Vermont Agency of Transportation  
 RECEIVED  
 June 12, 2014  
 For Construction  
 CONFORMANCE  
 By: Rob Burns DATE: 6/17/2014

ABUTMENT #1 PLAN

STRUCTURE: VTAOT WARREN BRF 013-4(32) PRECAST  
 LOCATION: BRIDGE 166 ROUTE 100 (MINOR ARTERIAL) WARREN, VT  
 ARCHITECT: [blank]  
 ENGINEER: [blank]  
 CUSTOMER: S.D. IRELAND CONCRETE CONST. CORP.  
 DRAWN BY: ED DATE: 2/18/14 DPT #: 8756  
 DRAWING COVERS: ABUTMENT #1 DUAL COATED REINFORCING DRAWING #: C

PLAN VIEW A-A

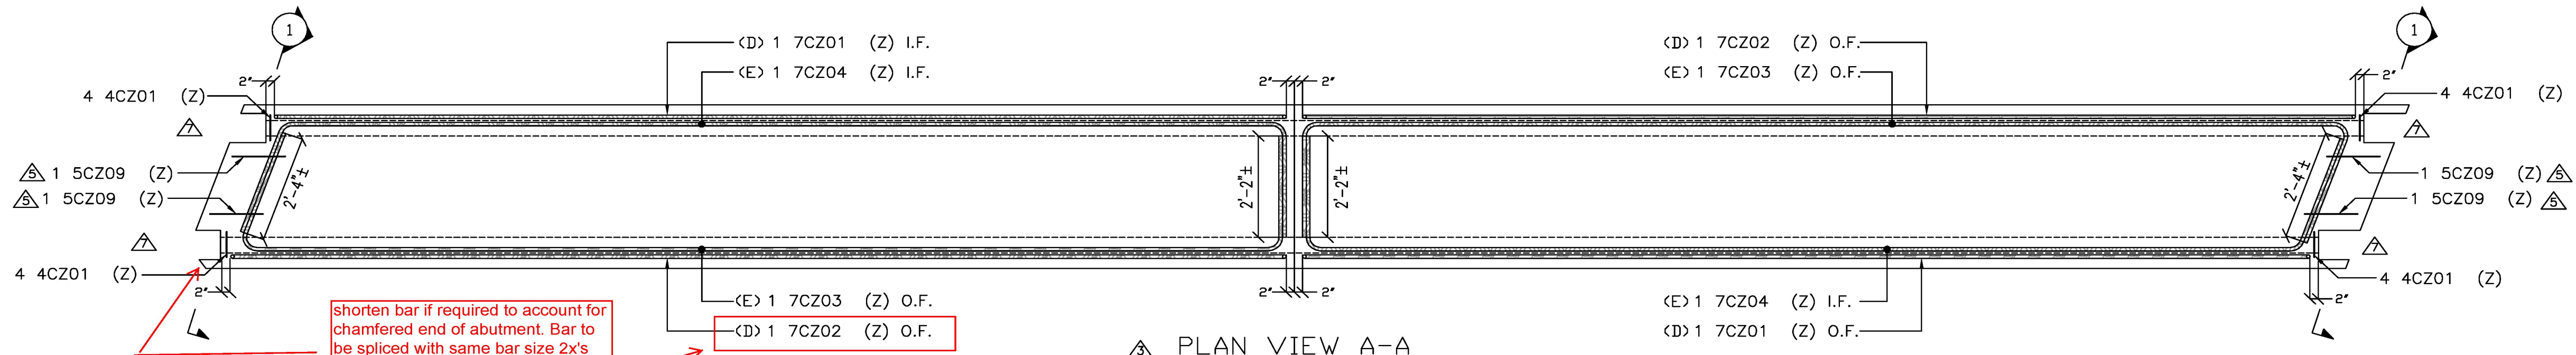
shorten bar if required to account for chamfered end of abutment. Bar to be spliced with same bar size 2x's the 53" lap distance.
